ELECTRICAL-ELEMENTARY DIAGRAM

STANDBY DIESEL GENERATOR

DIESEL CONTROL PANEL IHS1-POS4B

DRAWING NUMBER: B-208-216

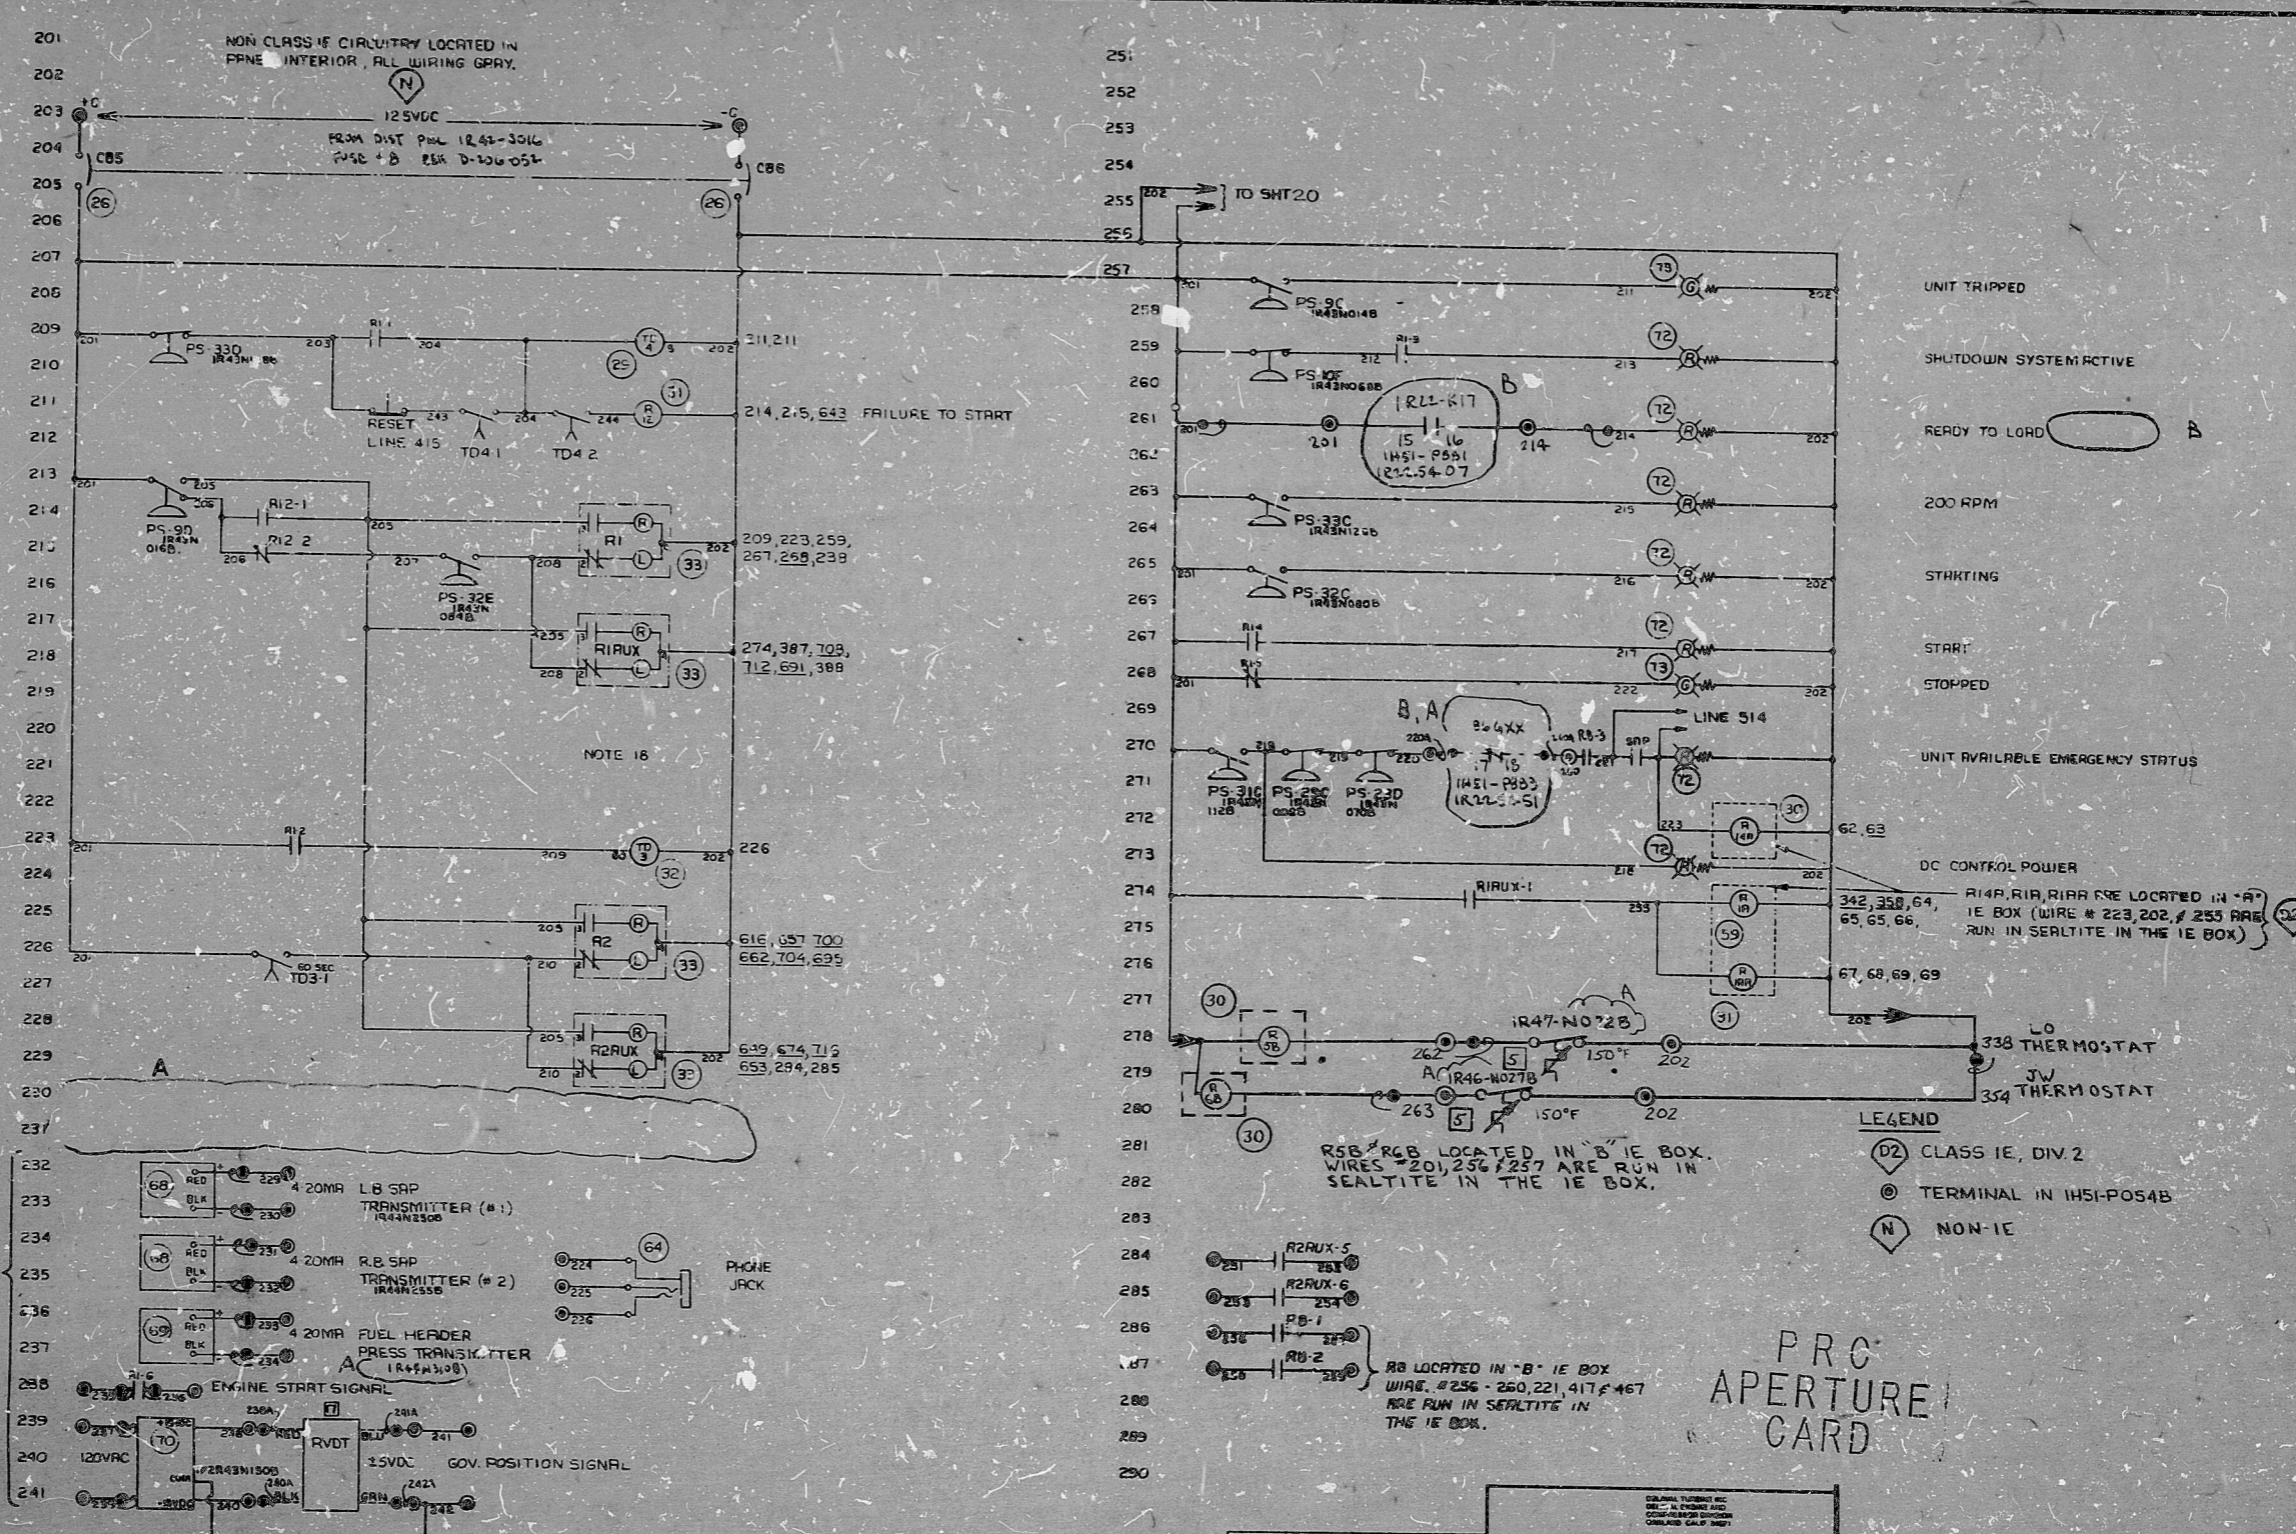
ADDED CONTACT IR2L-K17 (LINE 261) & B64X (LINE 270)

REMOVED 20V TANK LEVEL XMT & METER WIRING, LINES 230 & 231. REVISED TAG # LINE 237
